POOL BARRIER PLAN

Project:	PROPOSED POOL, SPA & ALFRESCO
Client:	CANN
Site:	35 KEEL RETREAT, PORT GEOGRAPHE

Sheet title	**POOL BARRIER PLAN**
Date	21 Oct 2026
Revision	A
Scale	1:100

A3-03

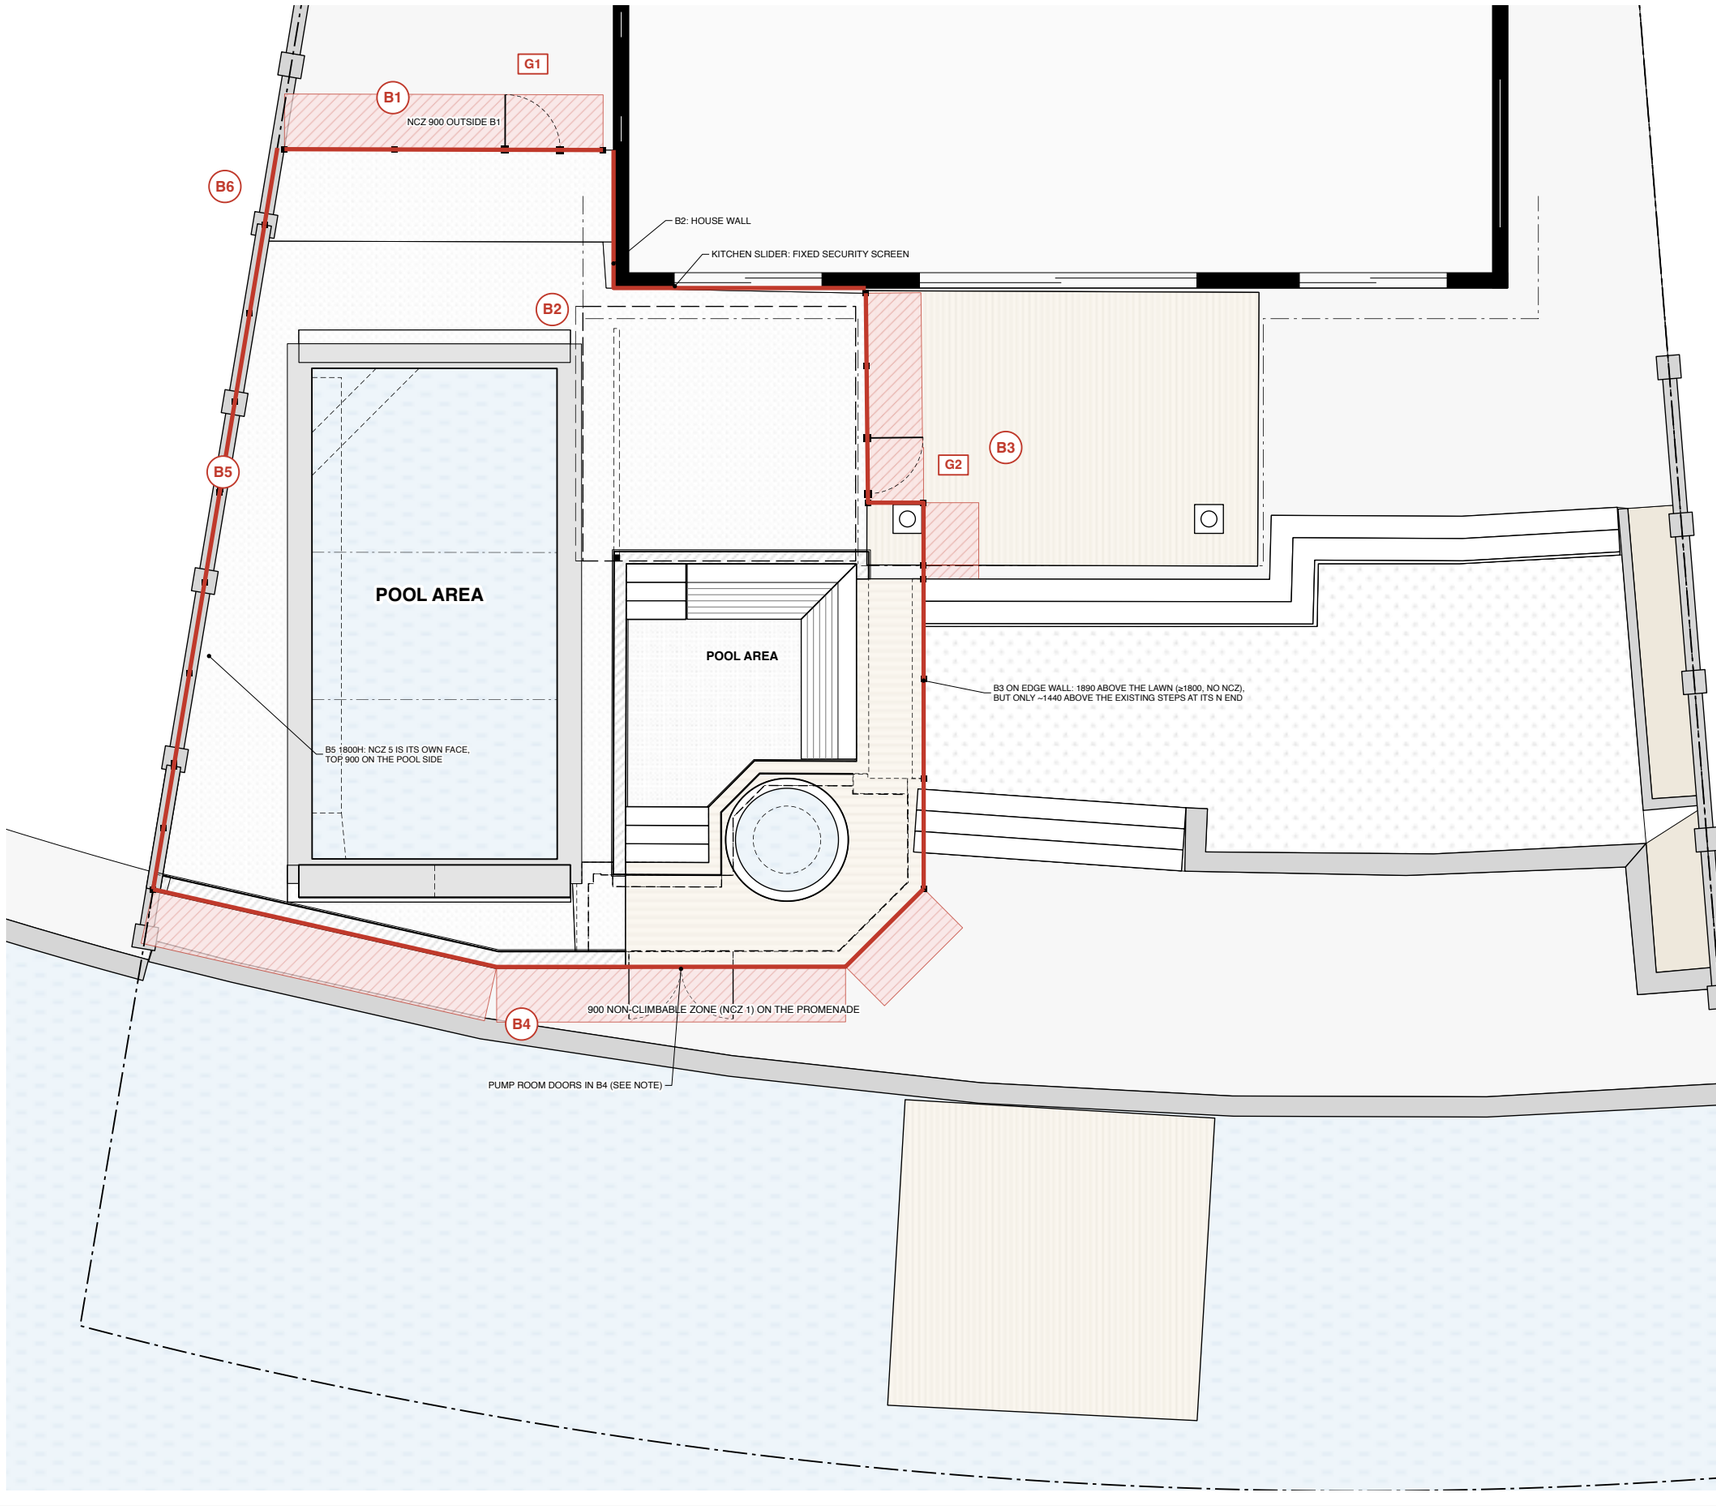
TO CONFIRM WITH BOB

- B3 at its north end: only about 1440 above the existing lawn steps against it. OK as is?
- Pump room doors in B4, the canal-side barrier wall: their outside face must be non-climbable. Which door and finish?
- B1 and B3 stop 170 and 90 short of the house wall: close them up.
